File	REGALI
Doc	FM TRANSMITTER
Document Number	
Rev	2.0
Author	AL
Doc	<Doc>
Date	Wednesday, January 15, 2003
Sheet	1 of 1

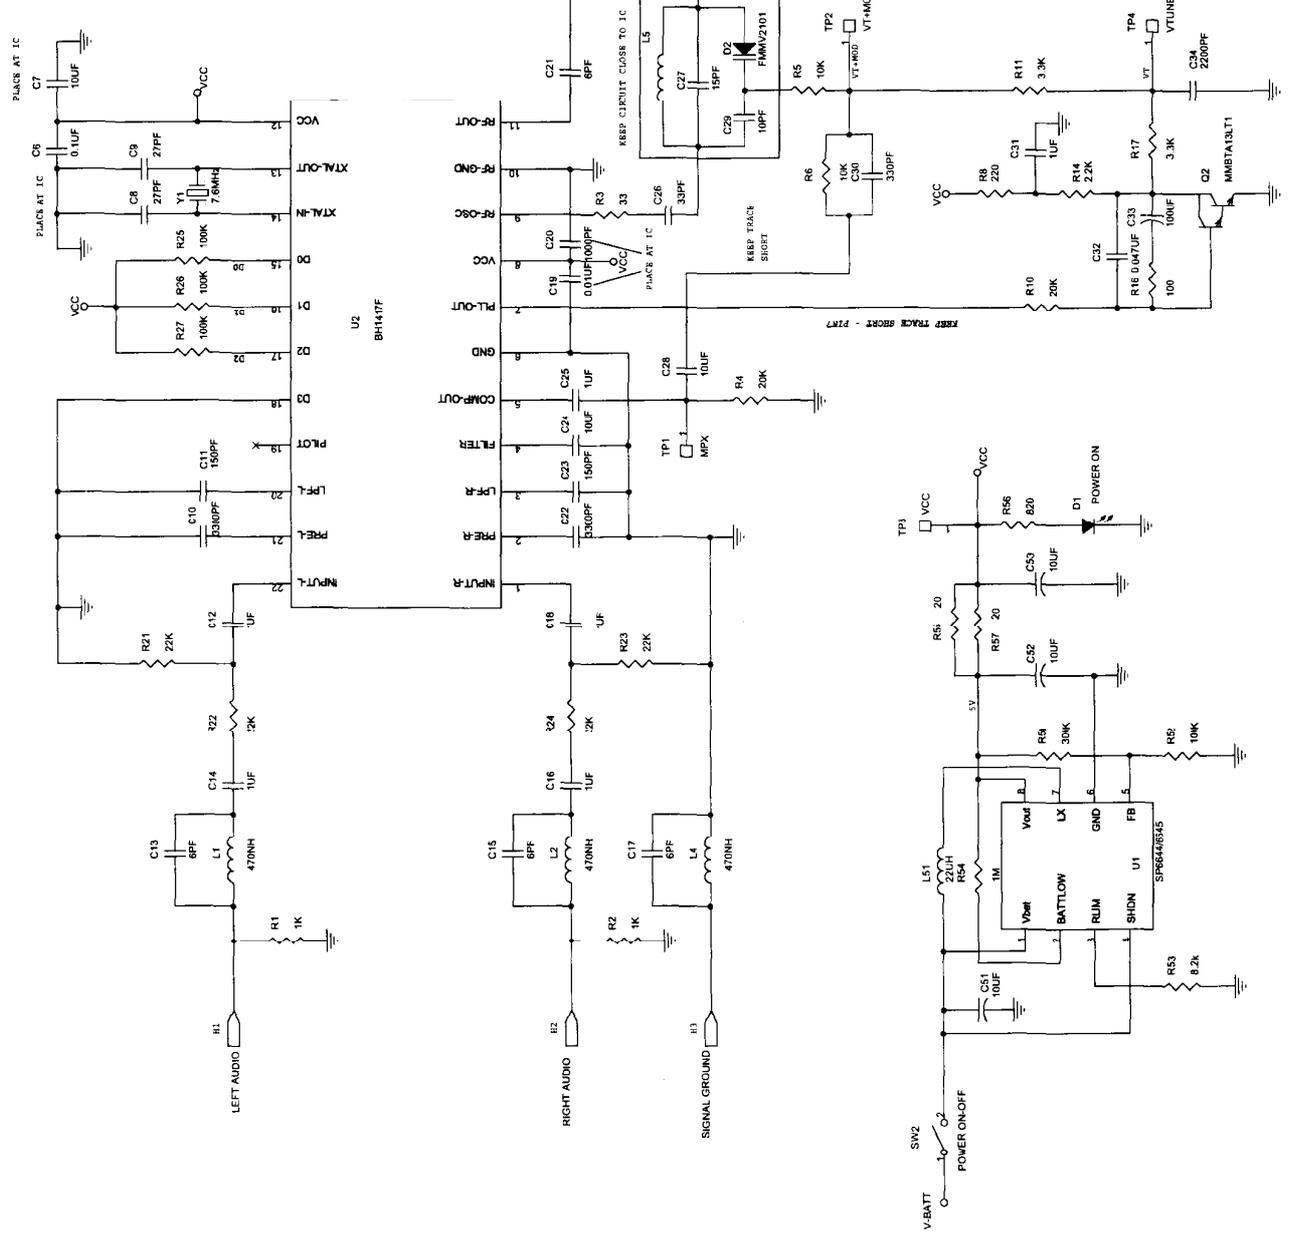
VER. 0	
REV. 2.0	1. CHANGE R53 TO R 2K 2. CHANGE R54 TO R 10K 3. CHANGE C27 FROM 80P TO 150P 4. CHANGE C29 FROM 100P TO 100PF
